# ConocoPhillips SAN JUAN 29-5 UNIT 77 Expense - P&A

Re: Permanent Abandonment Well: 77 San Juan 29-5 Unit

# **CONDITIONS OF APPROVAL**

|                | ozeofilille  |   |                       | posed Sc   | chematic                         |  | ***                |                                       |           |

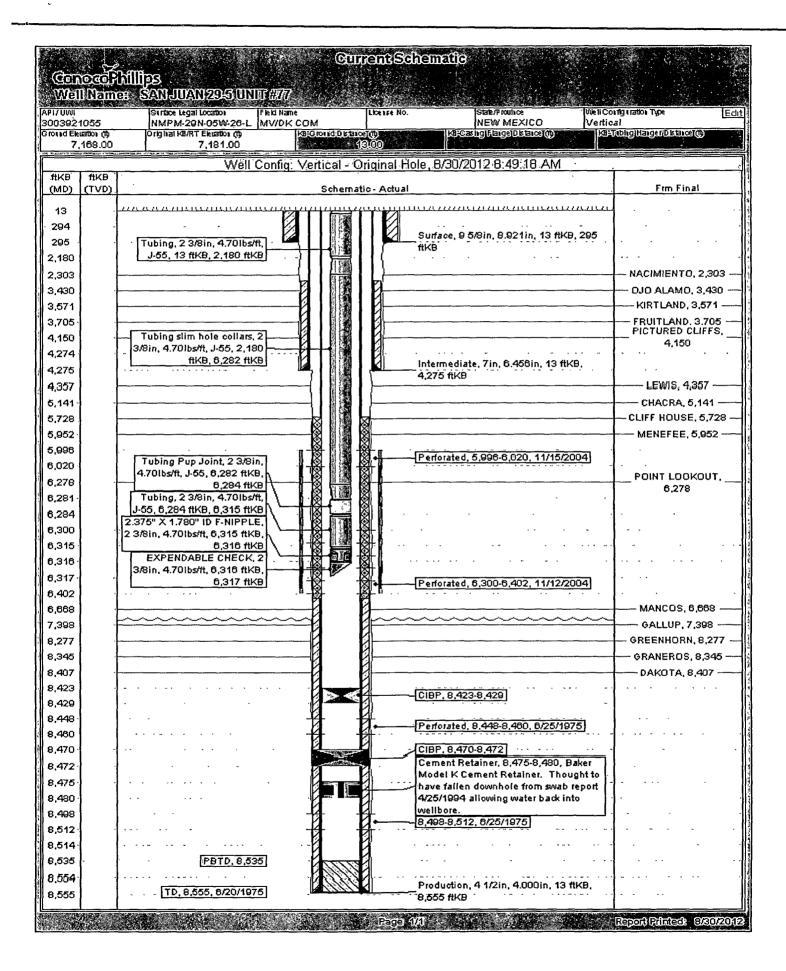
- 1. Plugging operations authorized are subject to the attached "General Requirements for Permanent Abandonment of Wells on Federal and Indian Lease."
- 2. Farmington Office is to be notified at least 24 hours before the plugging operations commence (505) 564-7750.
- 3. The following modifications to your plugging program are to be made:
- a) Place the Gallup plug from 7397' 7297'.
- b) Place the Chacra plug from 4932' 4832' inside and outside the 4 ½" casing.
- c) Bring the top of the 7" Casing Shoe/Pictured Cliffs plug to 4091' inside and outside the 4  $\frac{1}{2}$ " casing.
- d) Place the 4 1/2" Casing Stub/Fruitland/Kirtland/Ojo Alamo plug from 3893' 3380.
- e) Place the Nacimiento plug from 2276' 2176' inside and outside the 7" casing.

You are also required to place cement excesses per 4.2 and 4.4 of the attached General Requirements.
